Memorandum To: Community Development Committee From: Dawn Reinhart Date: 6/3/2019 File ID: 19-0872 Re: Action on OTP 1218 6<sup>th</sup> St

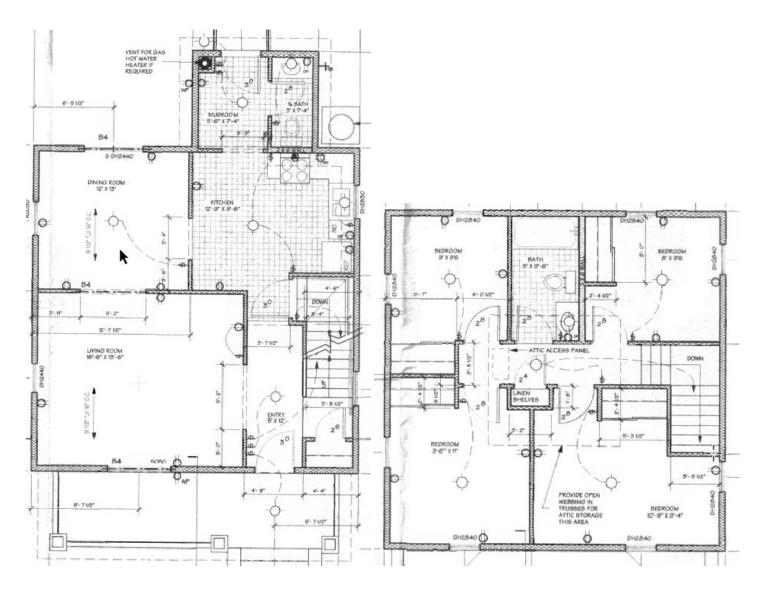
**Plan modifications:** One of the bedrooms will be eliminated on the 2<sup>nd</sup> level to create a master suite. The wall in between the digning room & kitchen will be removed and an island will be added to provide more cabinet/counter space. The front porch may not be concrete, it must be built out of a decking type material and decorative in nature. The rear porch may be concrete. The house shall have deocrative columns, a decorative front door and a band board around the house to break up the siding.

With the exterior changes the design score is 32 out of 37 points. There is a loss of 4 points for not commiting to focus on energy certification. Buyer is in the process of consulting Staff to determine what changes would need to be made to achieve this certification.

**Staff recommendation:** Accept the OTP contingent upon the plan modifications are presented to Staff and approved prior to closing.
